In fulfillment of the Interagency Agreement between our respective government organizations, attached is Task 1: Bureau of Mines Review of Department of Energy Report "Exploratory Shaft Design Basis Study Review."

Task 1: Bureau of Mines Review of Department of Energy Report

"Exploratory Shaft Design Basis Study Review"

Expression for parallel constant head boundaries:
(from ODL Strack, 1987, page 352)

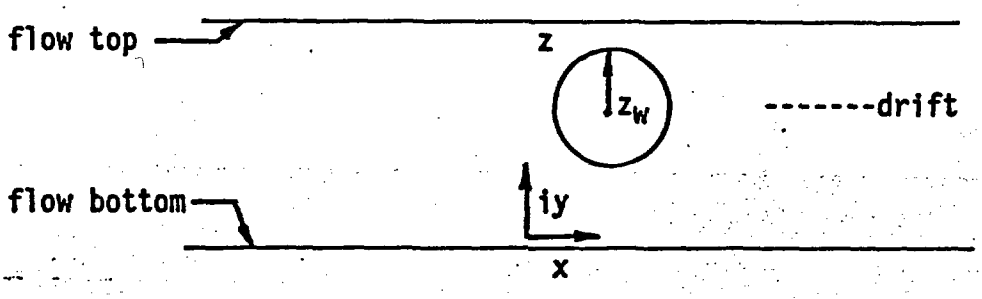
I was able to find an analytic solution to the same problem, derived using a conformal mapping technique involving Schwartz-Christoffel transformations. The solution is in a book entitled, "Groundwater Mechanics" by Otto D.L. Strack, Prentice Hall 1987, pages 350-352. Since I have the book in manuscript form, I am not sure if these page numbers are still correct; however, it is in a section entitled, "Applications of Conformal Mapping." The expression (on the next page) is developed as an exact solution for flow to a well that is located midway between two infinitely long, parallel, constant head boundaries.

This solution is more general than the one presented in your report and would permit specification of the drift at different elevations relative to the interflow boundaries. It can also be modified to permit a difference in head boundary conditions above and below the drift, or a uniform ground water flow gradient through the flow interior. (You indicated earlier that there was an upward vertical flow gradient). If you assume the drift (well) is located exactly midway between the two boundaries, I have verified that this solution reduces to the one presented on page 59 of the report.
